The Commission has issued the enclosed Amendment No.71 to Facility Operating License No. DPR-67 for the St. Lucie Plant, Unit No. 1. This amendment consists of changes to the Technical Specifications in response to your application dated July 19, 1985.

This amendment revises the Technical Specifications to permit continued operation at rated thermal power for a specified time following a dropped control element assembly and reformulates the Action statements of Technical Specification 3.1.3.1.

ATTACHMENT TO LICENSE AMENDMENT NO. 71  
TO FACILITY OPERATING LICENSE NO. DPR-67  
DOCKET NO. 50-335

SAFETY EVALUATION BY THE OFFICE OF NUCLEAR REACTOR REGULATION

Figure 3.1-1a Allowable Time to Realign CEA vs. Initial  $F_T$

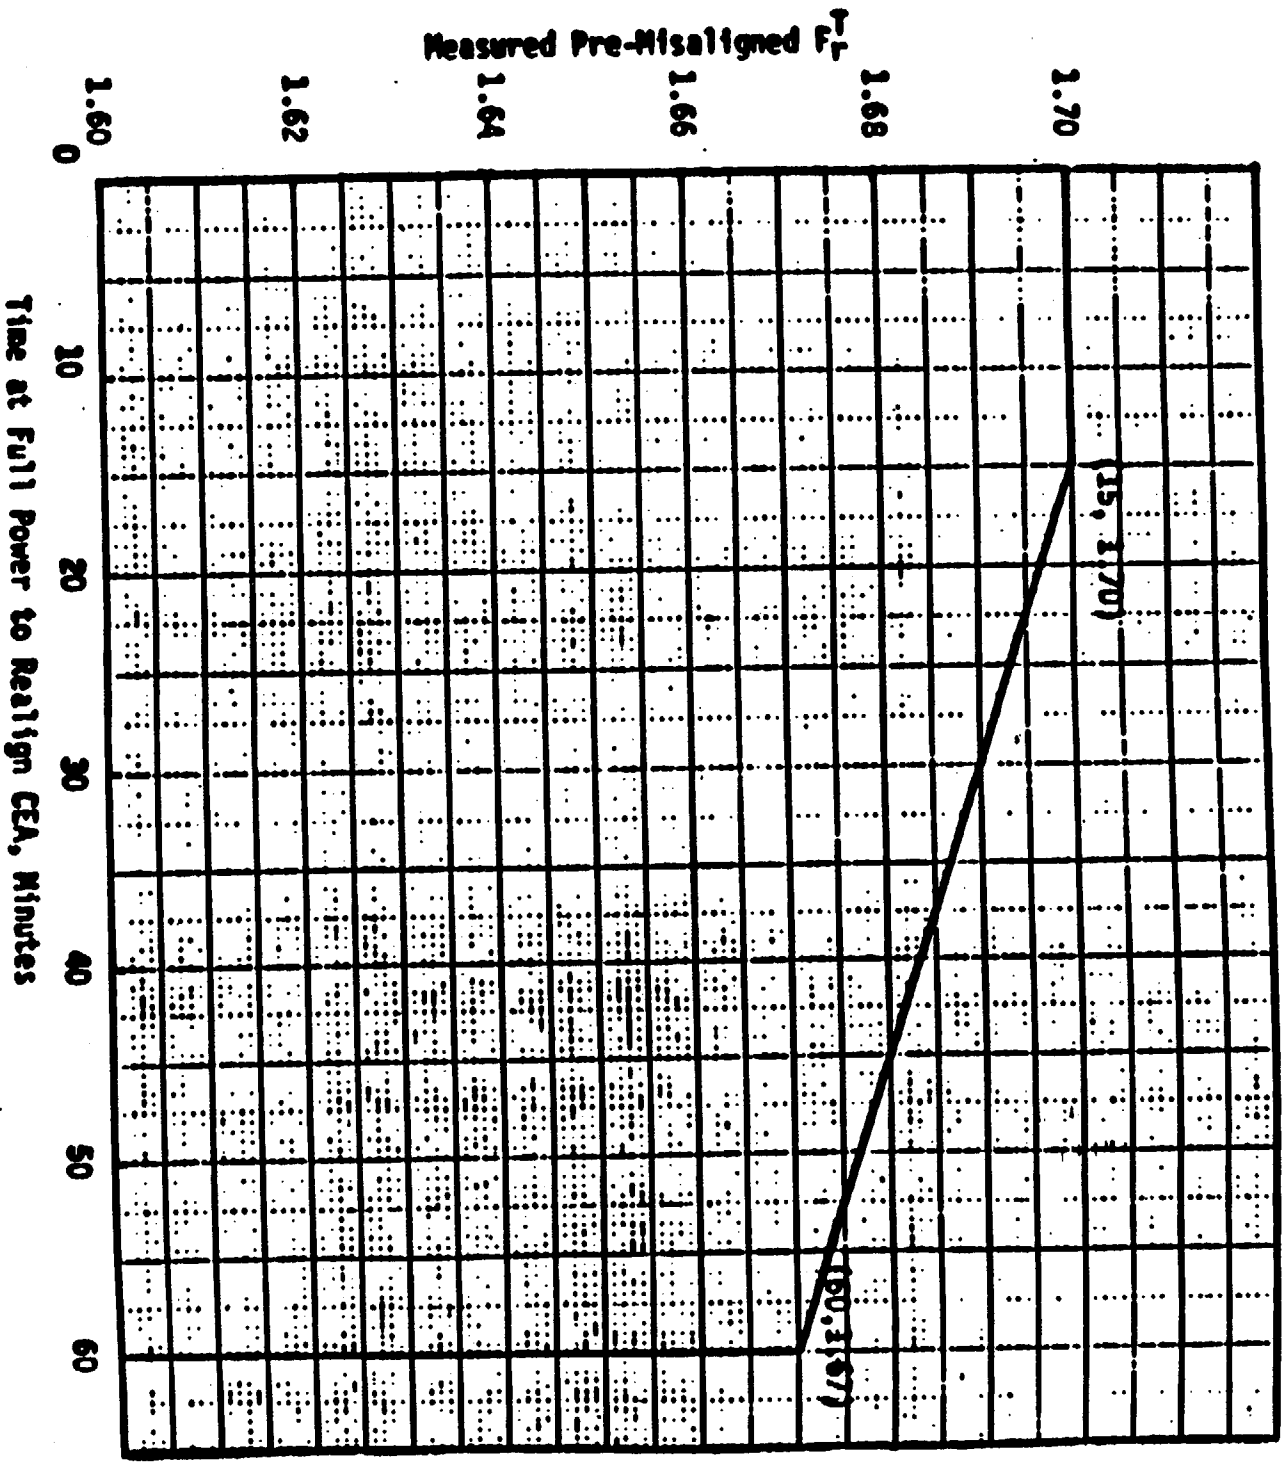
- e. With one full length CEA misaligned from any other CEA in its group by 15 or more inches, operation in MODES 1 and 2 may continue provided that the misaligned CEA is positioned within 7.5 inches of other CEAs in its group in accordance with the time constraints shown in Figure 3.1-1a.

- f. With one full-length CEA misaligned from any other CEA in its group by 15 or more inches beyond the time constraints shown in Figure 3.1-1a, reduce power to  $\leq$  70% of RATED THERMAL POWER prior to completing ACTION f.1 or f.2.

The licensee has proposed to incorporate the attached Figure 3.1-1a into the St. Lucie 1 Technical Specifications showing the allowable time to realign a dropped CEA as a function of the initial value of  $F_p$ . The figure permits only 15 minutes of full power operation when the pre-drop value of  $F_p$  equals 1.70 even though the analyses show that at least 1 hour would be permissible. As the pre-drop value of  $F_p$  decreases to 1.67, operation at full power for up to 1 hour is allowed. Based on the CEA drop analyses mentioned previously, the staff finds this acceptable.
